Proposed TS Pages

9209110157 920204
PBR HDOCK 05060221
PBR

FIGURE 4.1-1. GRAPHICAL AID FOR THE SELECTION OF AN ADEQUATE INTERVAL BETWEEN TESTS.

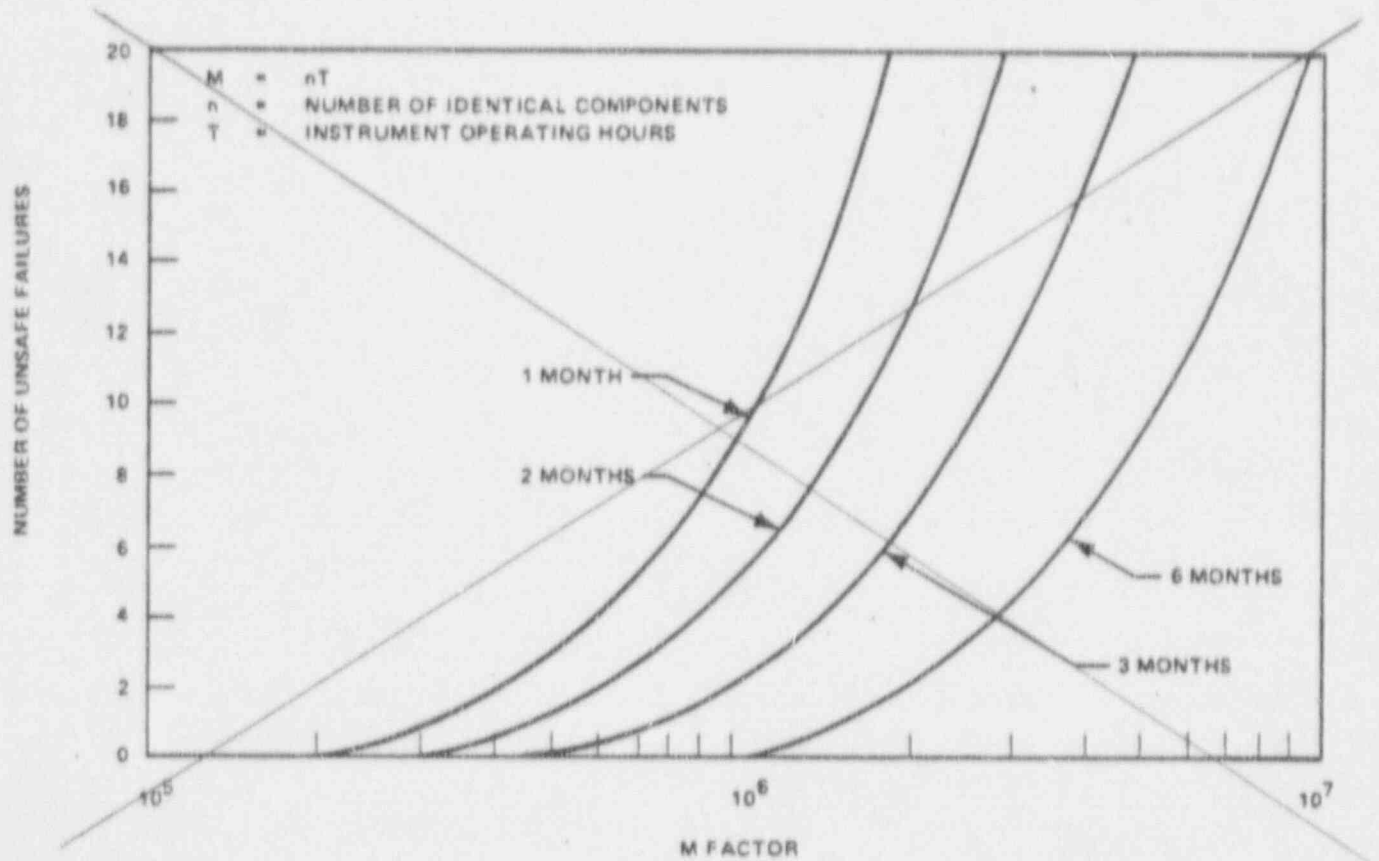
3. The accumulated number of unsafe failures is plotted as an ordinate against M as an abscissa on Figure 4.1-1.
4. A test interval of one result will be used initially until a trend is established.
5. After a trend is established, the appropriate test interval to satisfy the goal will be the test interval to the left of the plotted points.

The bi-stable devices are monitored during plant operation to record their failure history and establish a test interval using the curve of Figure 4.1-1. There are numerous identical bi-stable devices used throughout the plant's instrumentation system. Therefore, significant data on the failure rates for the bi-stable devices should be accumulated rapidly.

(Delete)

Figure 4.1-1 Deleted

FIGURE 4.2-1. SYSTEM UNAVAILABILITY

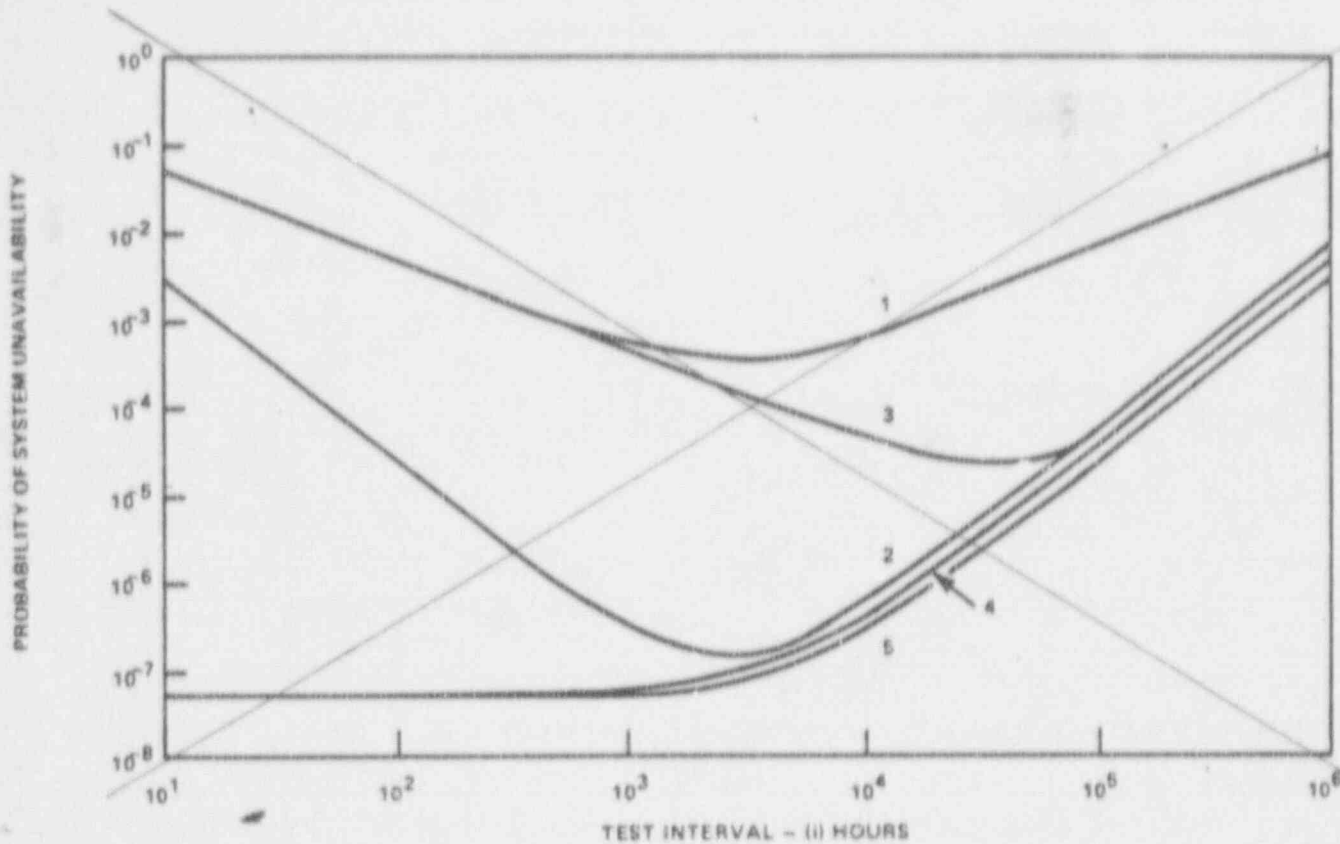
The formula given above minimizes the unavailability of a single channel which must be bypassed during testing. The minimization of the unavailability is illustrated by Curve No. 1 of Figure 4.2-1 which assumes that a channel has a failure rate of 0.1×10^{-6} /hour and that 0.5 hours is required to test it. The unavailability is a minimum at a test interval t , of 3.16×10^2 hours.

(Delete)

FIGURE 4.2-1 Deleted
